Job Title  
99 High Street  
Bromley, Kent BR1 1JQ

Drawing Title  
Proposed GF  
COMMERCIAL

Drg. No. PL066-1 Rev. A

**PROPOSED 1:50**  
SHOP FRONT

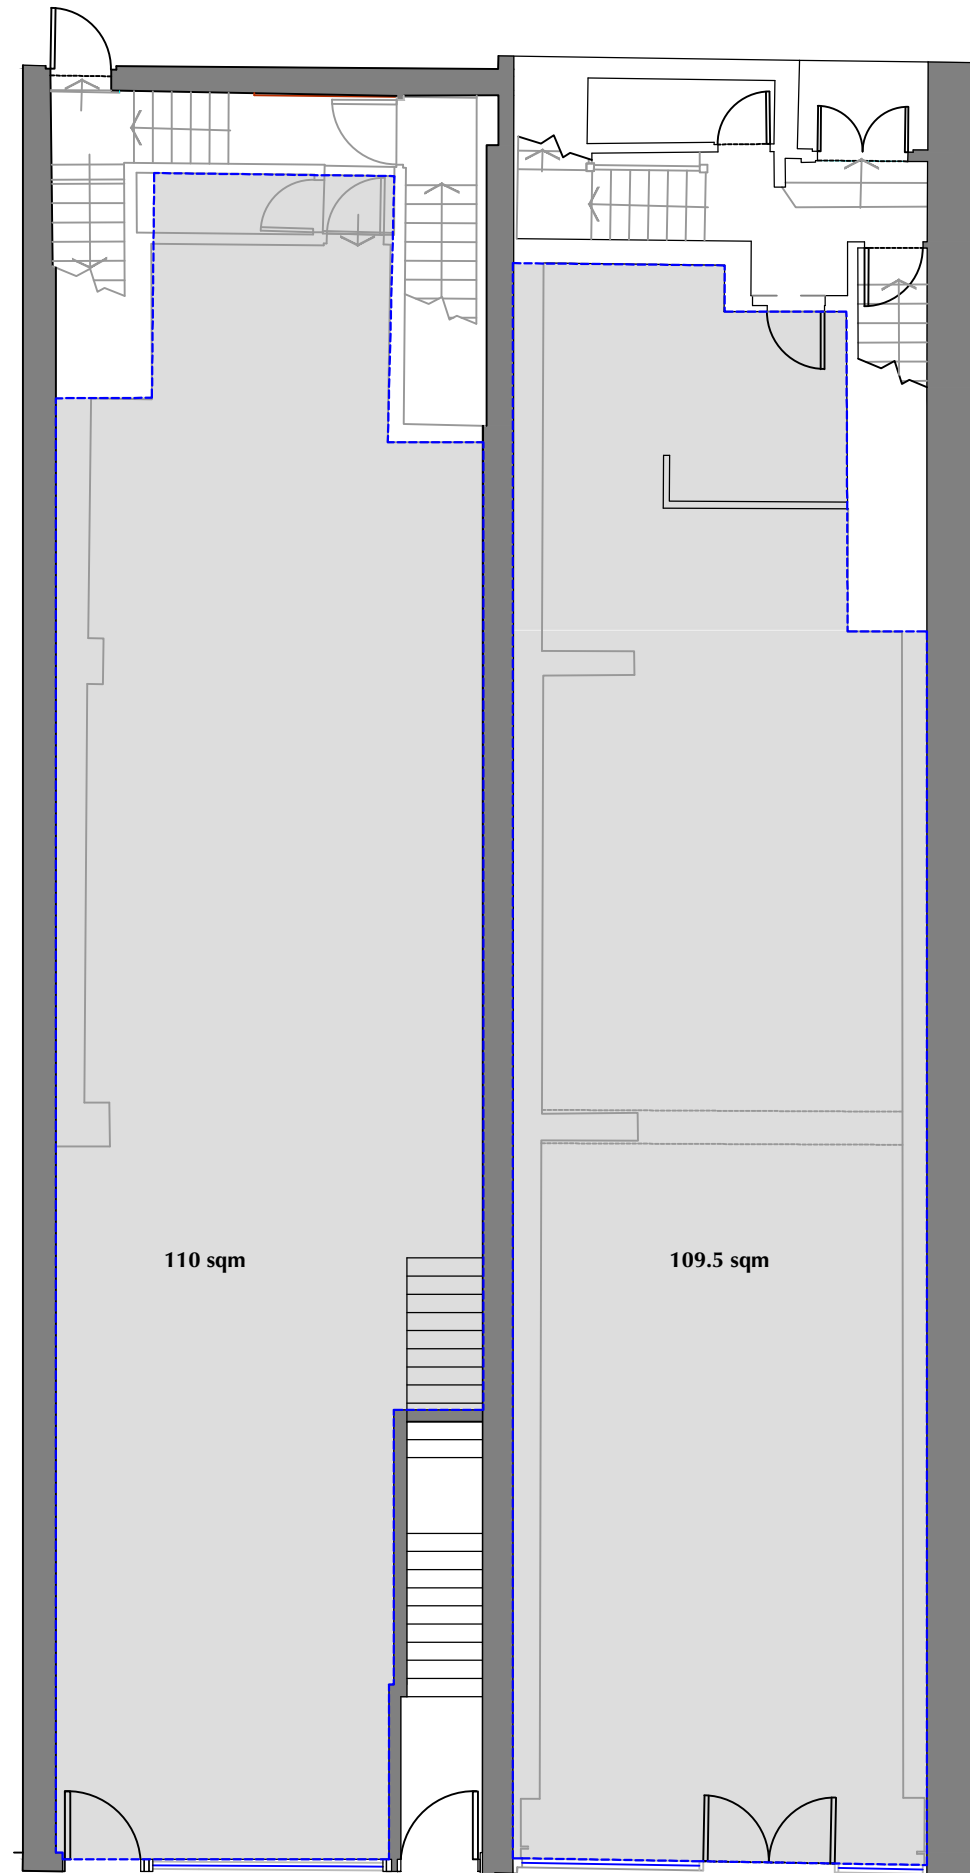
Mullions should line up above and below the transom and may reflect vertical alignment of windows in the upper floors.

A transom should divide the window at the same level as the line between the doors.
